From: Tweed Estuary General Commercial Fishers

This letter has been written to make a submission on Tweed Shire Council's proposed Chinderah Pontoon. We have been told by Patrick Dwyer from Fisheries that Council would accept a late submission as none of us saw the ad for the proposal as it has been the mullet season, a very busy time for fisherman.

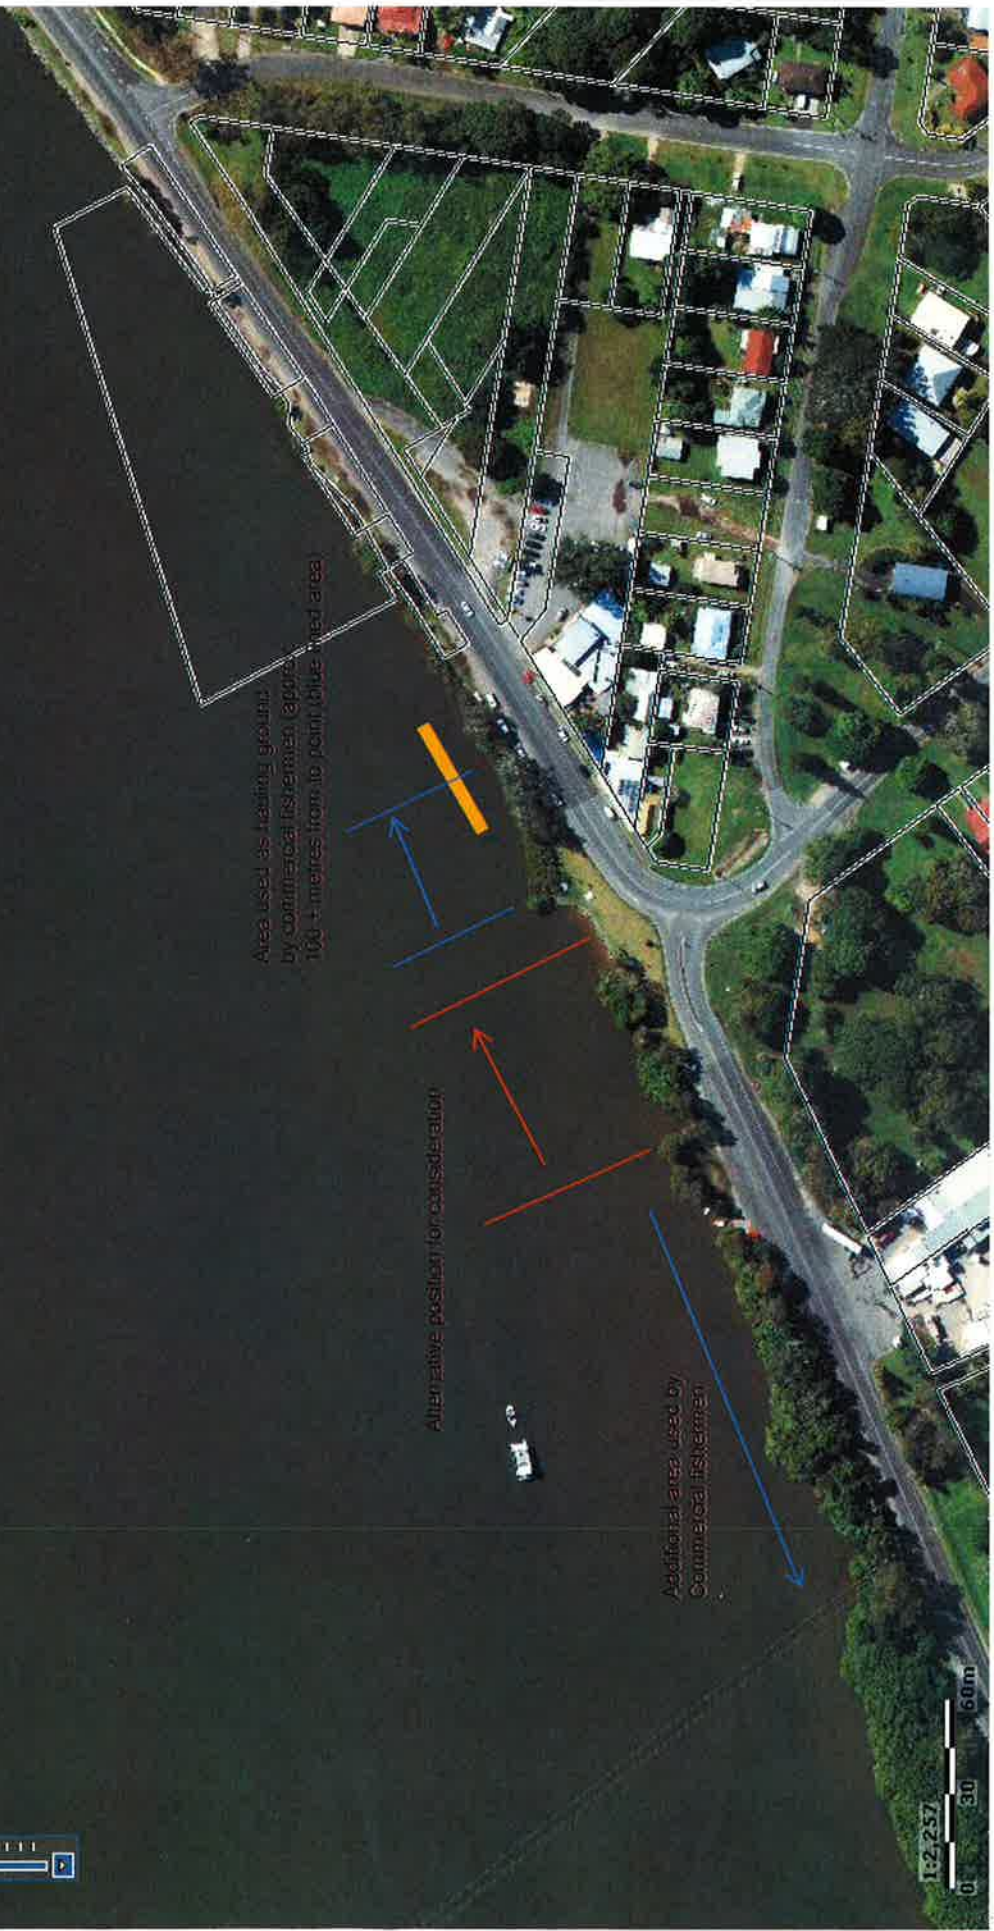
As you are aware, the developer lost the case. I don't think its unreasonable for the commercial fisherman themselves to have a say in whether or not the loss of a haul shot will be a big or small impact on our operations. The aerial photo attached to this letter has a drawing of the haul area we use.

Area used as fishing ground by commercial fishermen approx 100 metres from to point (blue lined area)

Alternative position for consideration

Additional area used by Commercial fishermen
